INCH-POUND
MIL-PRF-19500/717A
w/AMENDMENT 1
22 April 2026
SUPERSEDING
MIL-PRF-19500/717A
23 May 2022

PERFORMANCE SPECIFICATION SHEET

SEMICONDUCTOR DEVICE, DIODE, NON-HERMETIC, EPOXY, SURFACE MOUNT, SILICON, BIDIRECTIONAL TRANSIENT VOLTAGE SUPPRESSOR, TYPES 1N6036AUG THROUGH 1N6072AUG, 1N6036AUJ THROUGH 1N6072AUJ, JANP, JANPTX, AND JANPTXV

FIGURE 1. Physical dimensions.

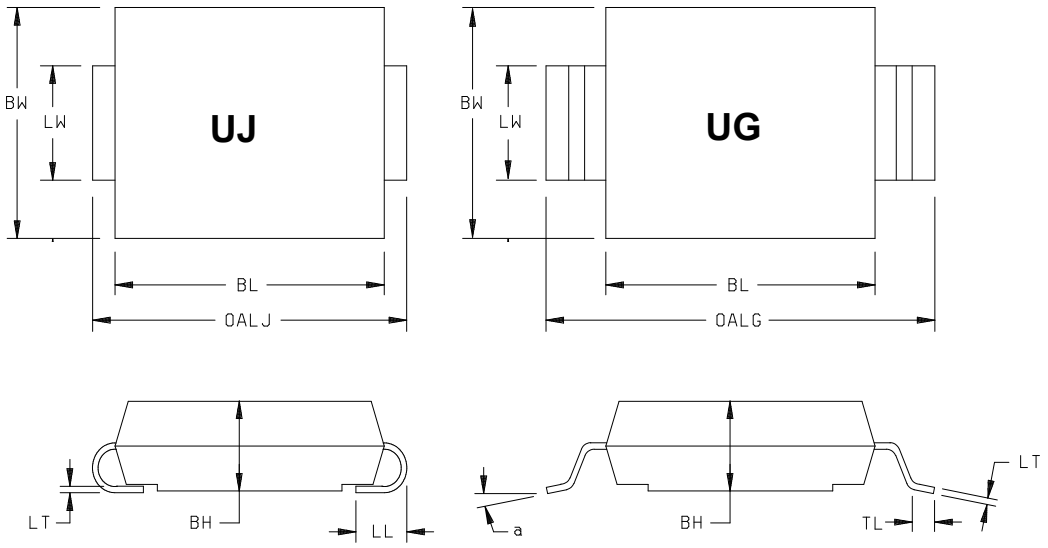
* NOTES:
1. Dimensions are in inches. Millimeters are given for general information only.
2. UG indicates Gull-Wing lead configuration; UJ indicates a J-Lead configuration.
